Access Compliance Report Public Rights-of-Way (RR Crossings)

Intersection ID: 10025384	Main Street: E_9TH_ST	Location: N/A
ADA ID: 35D2A74283BD	Overall Compliance: No	Severity Score: 0.0
Codes/Mitigation Info/Possible Solution		Field Measurements/Component Compliance

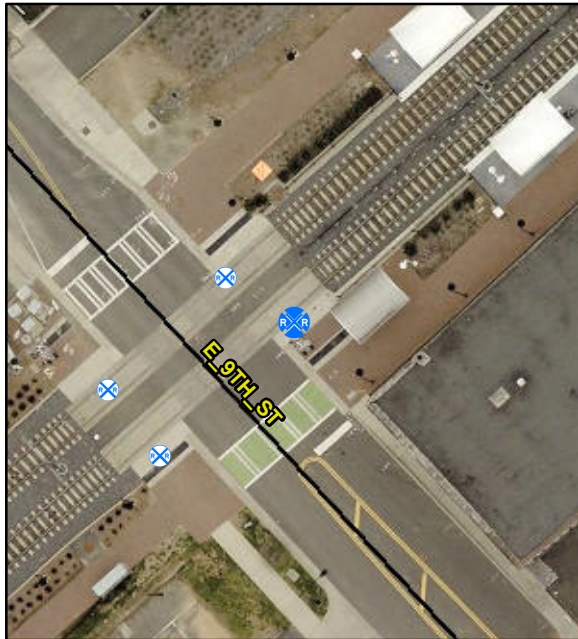
**Remove & Replace Detectable
Warning System. Provide Pedestrian
Gate. Remove & Replace Walking
Surface Adjacent to Rail.**

R302.7.4, R305.2.5

Compliance	Description	Data
Yes	DWS Provided?	Yes
Yes	DWS Contrast?	Yes
Yes	DWS Width (in)	Yes
Yes	DWS Length (in)	24.0
Yes	DWS Offset (in)	146.0
No	Pedestrian Gate?	No
N/A	DWS Outside Gate?	No
N/A	Rail Type?	LightRail
No	Flangeway Gap (in)	3.0
Yes	Sidewalk Width (in)	183.5
